## PUBLIC UTILITIES COMMISSION

**RE: Deficiency Report #4 - Certificate of Public Convenience and Necessity for the  
Riverside Transmission Reliability Project – Application No. A.15-04-013**

# DEFICIENCY REPORT #4 FOR THE RIVERSIDE TRANSMISSION RELIABILITY PROJECT APPLICATION (A. 15-04-013)

**CPUC Riverside  
Work Area Constraints  
Mapbook**

Map 18 of 22

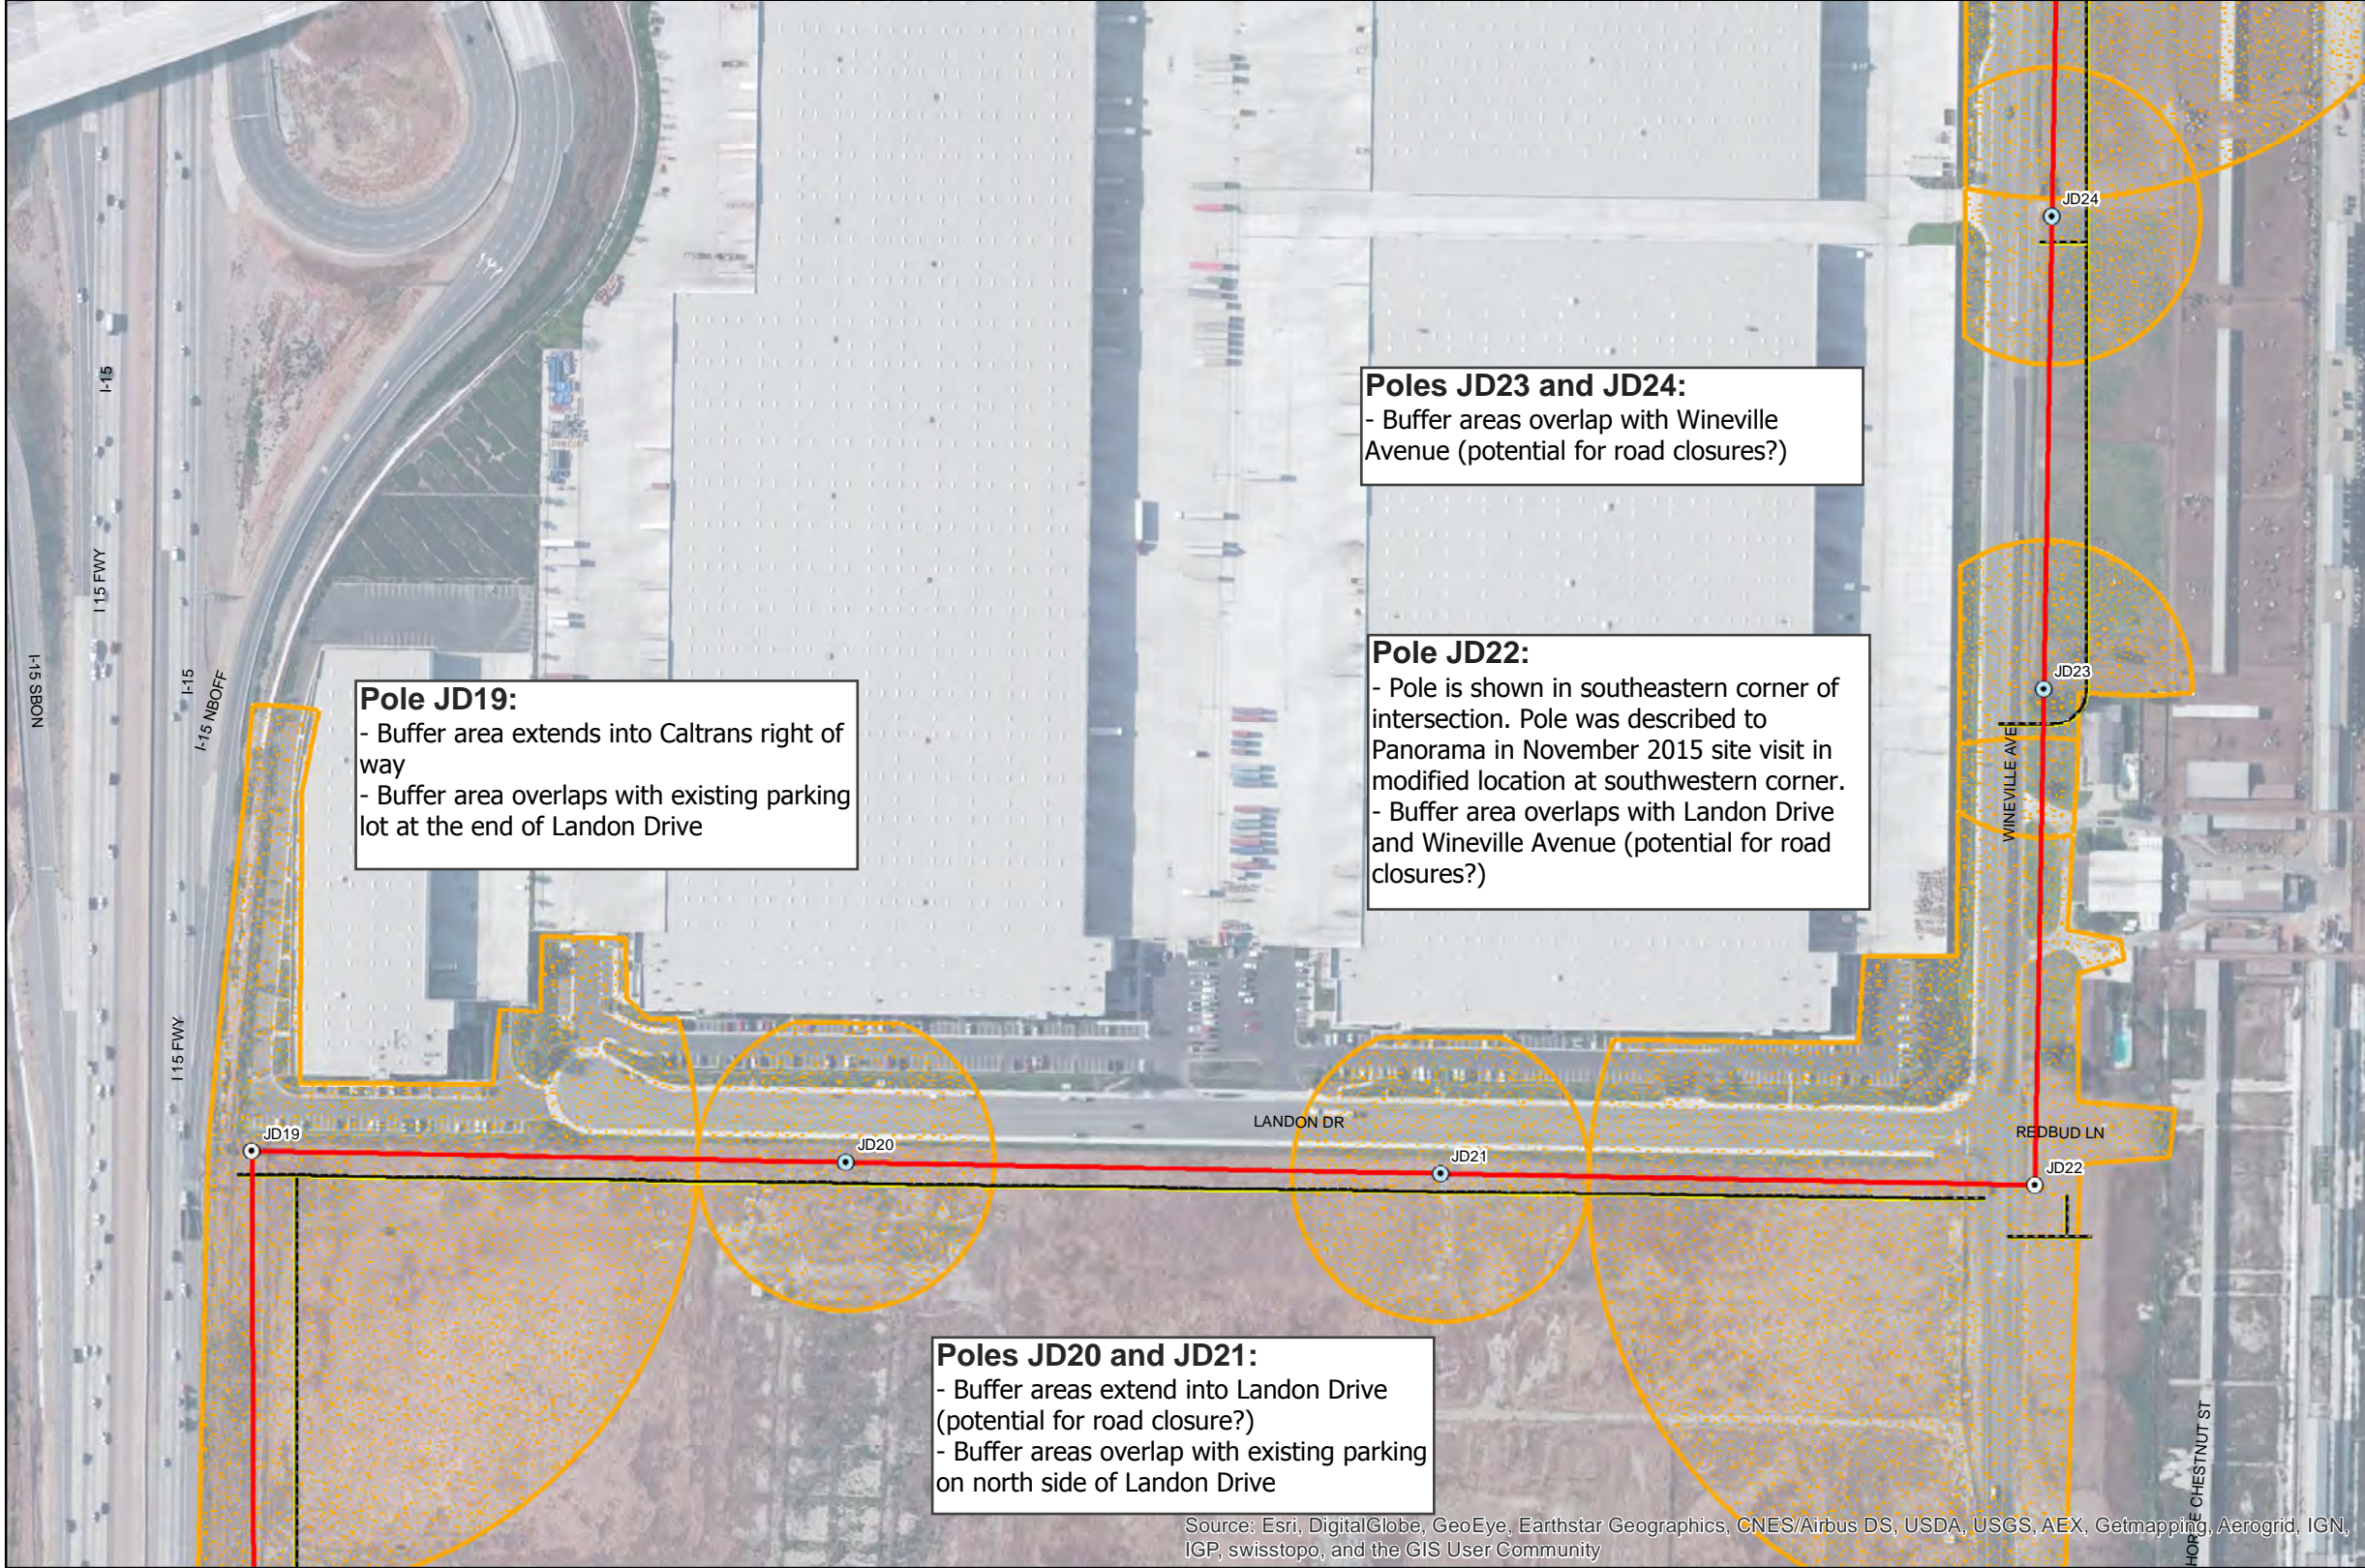
**Poles JD17 and JD18:**  
- Buffer areas extend into Caltrans right of way

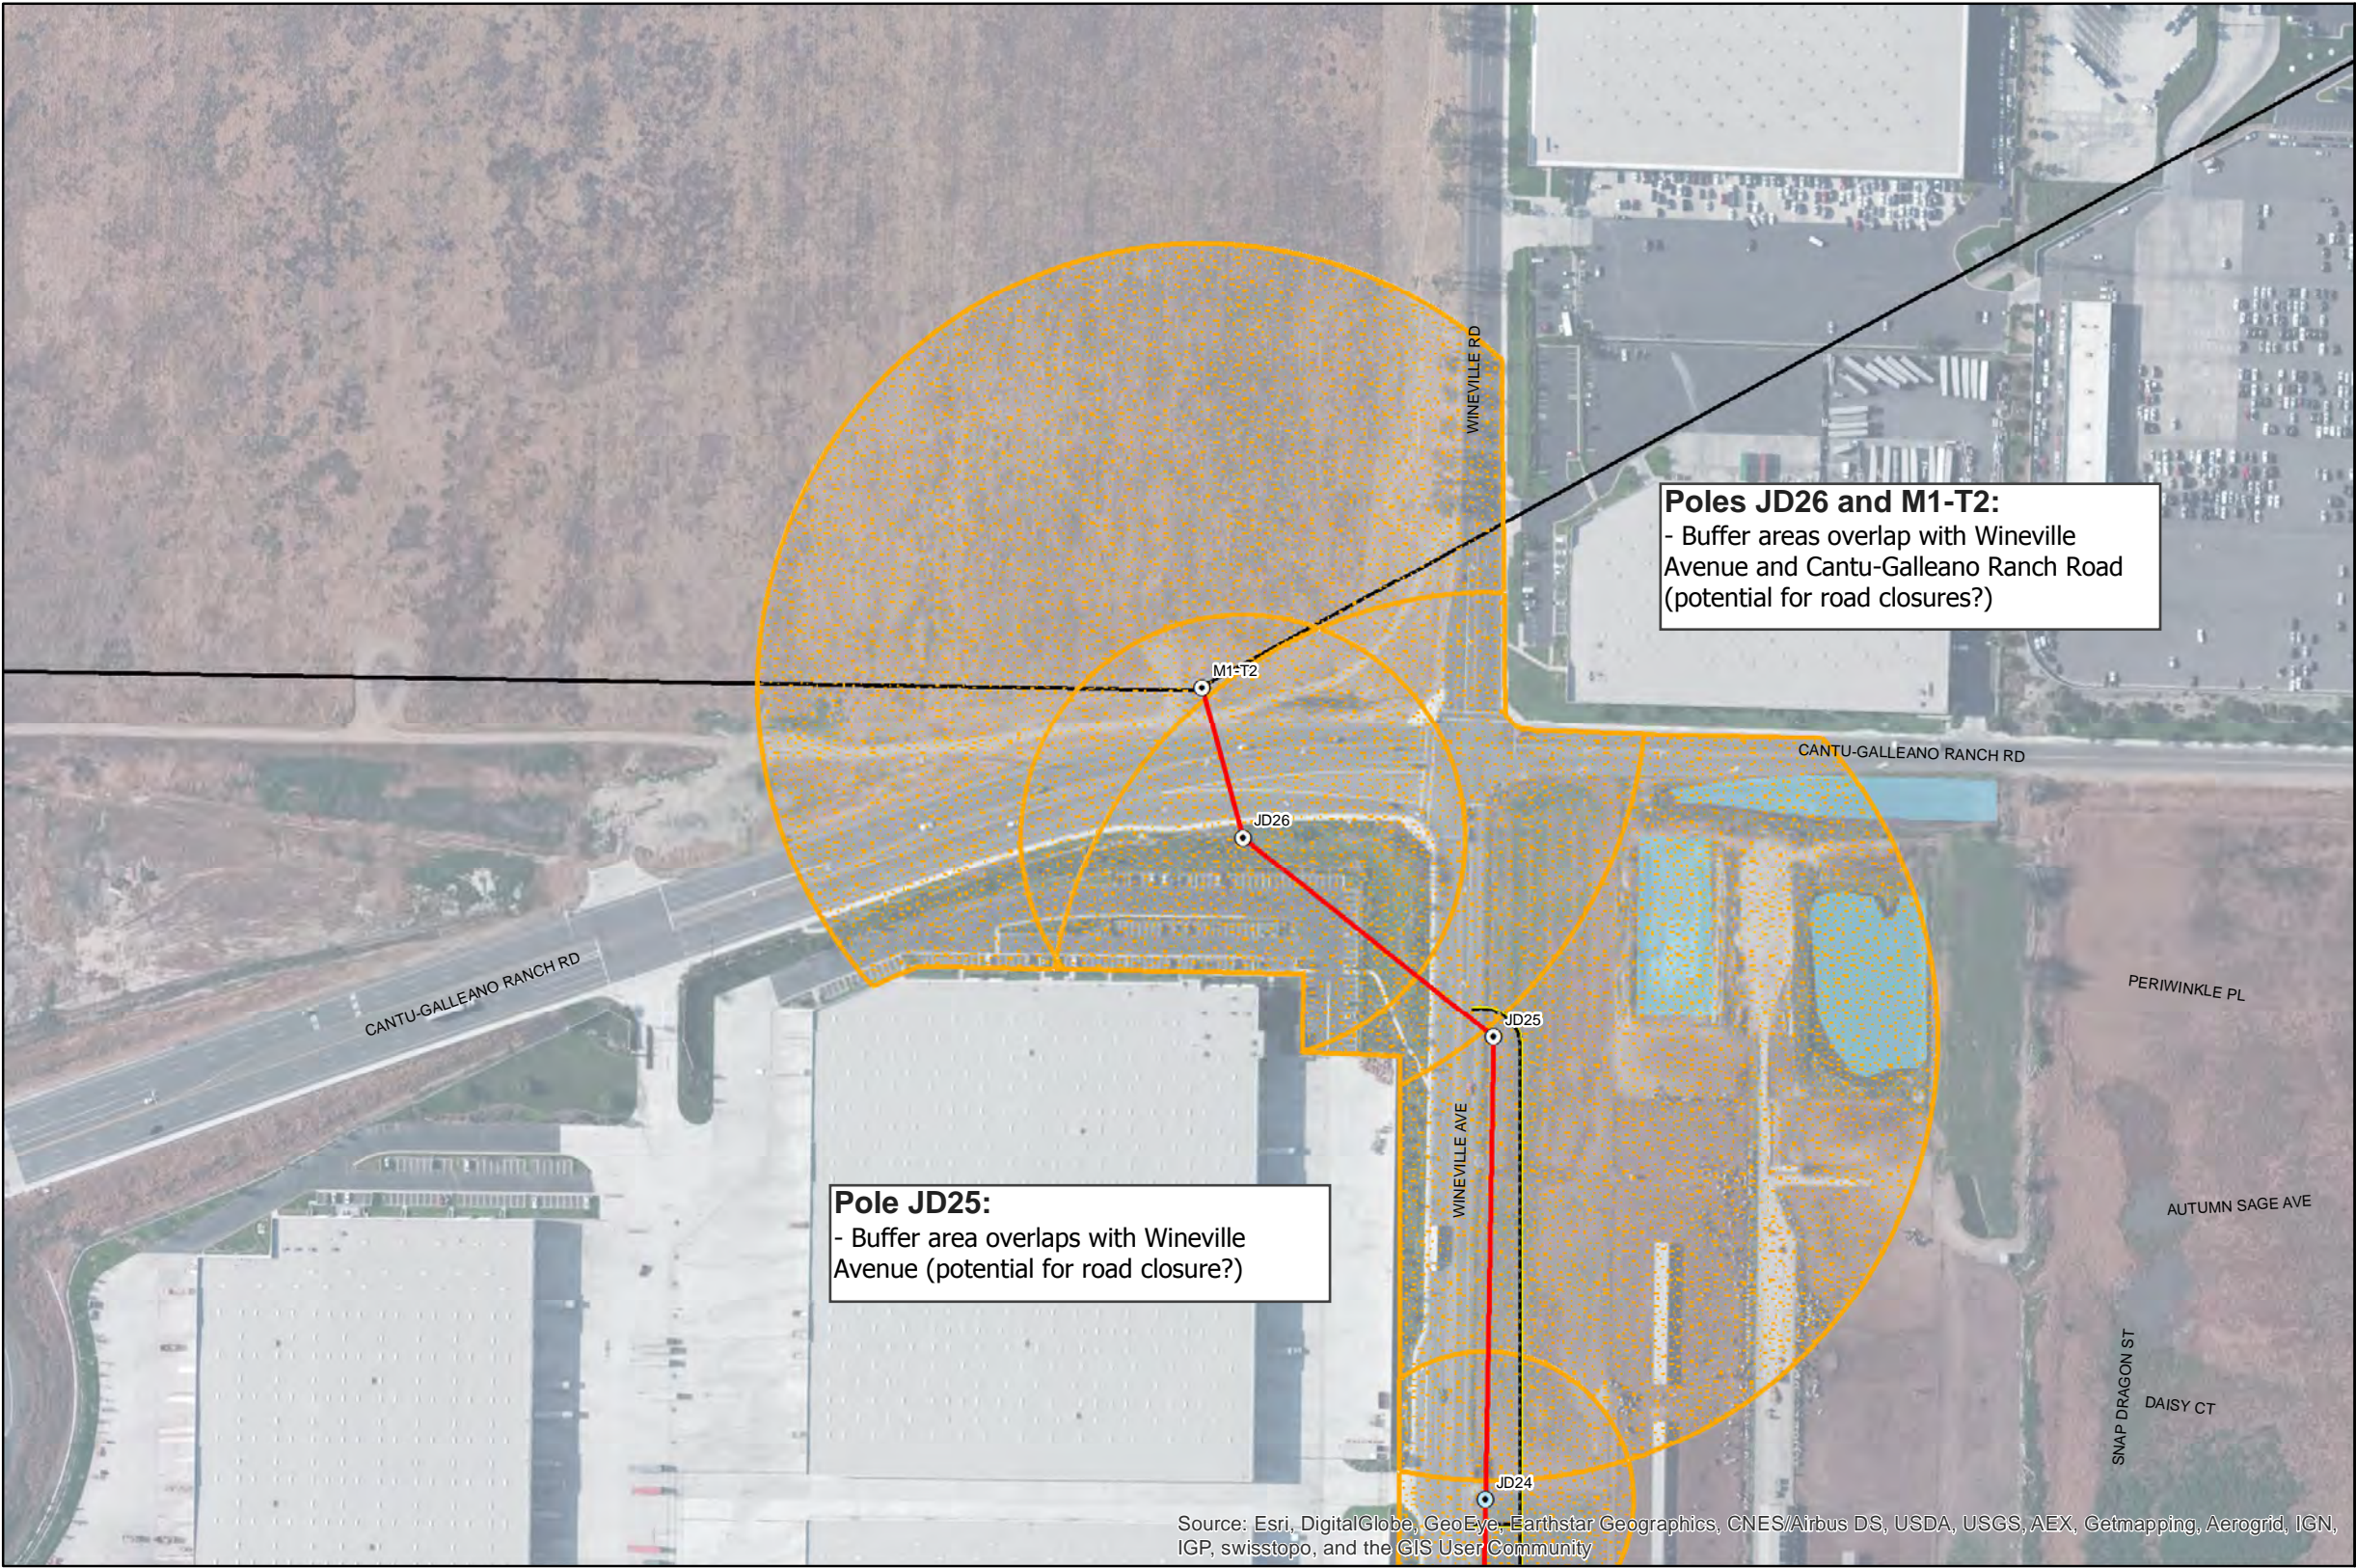
**Poles JD26 and M1-T2:**  
- Buffer areas overlap with Wineville Avenue and Cantu-Galleano Ranch Road (potential for road closures?)

**Pole JD25:**  
- Buffer area overlaps with Wineville Avenue (potential for road closure?)
